MATILIJA DAM REMOVAL, SEDIMENT TRANSPORT, AND ROBLES DIVERSION MITIGATION PROJECT

WATER SUPPLY MITIGATION OPTIONS EVALUATION REPORT MARCH 2016

Prepared for:
Ventura County Watershed Protection District

- Attachment 1 Design Oversight Group Comments
- Attachment 2 Design Oversight Group Comment Responses

Figure ES-1 provides a graphical representation of the current water consumption, projected water demand through year 2020, and the anticipated water supply range over the same time period.

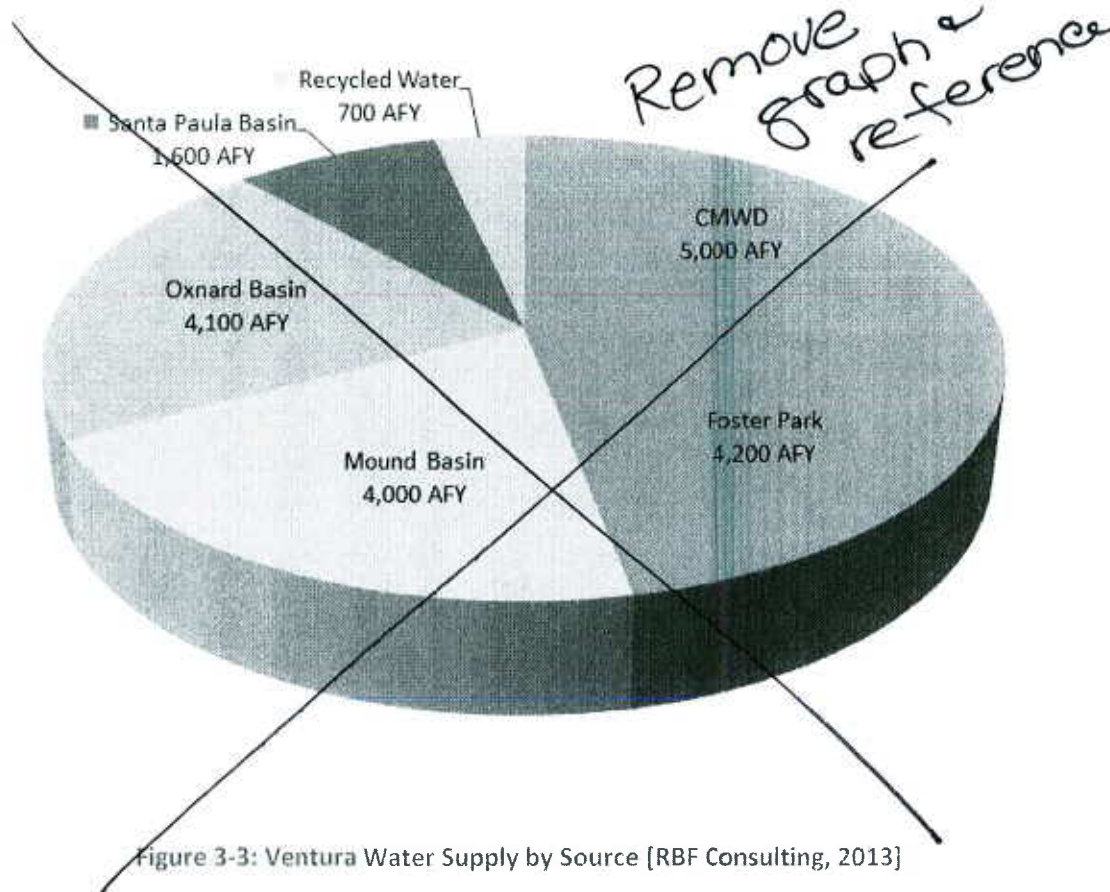
From CMWD, Ventura Water is allowed the maximum amount of its in-district demand, which varies, but is approximately 5,000 AFY on average. This represents a significant proportion of the City's current ~~total in-district and out of district water supply, which ranges from 18,000 AFY to 19,600 AFY. Figure 3-3 below presents the City's typical water supply volumes by source.~~
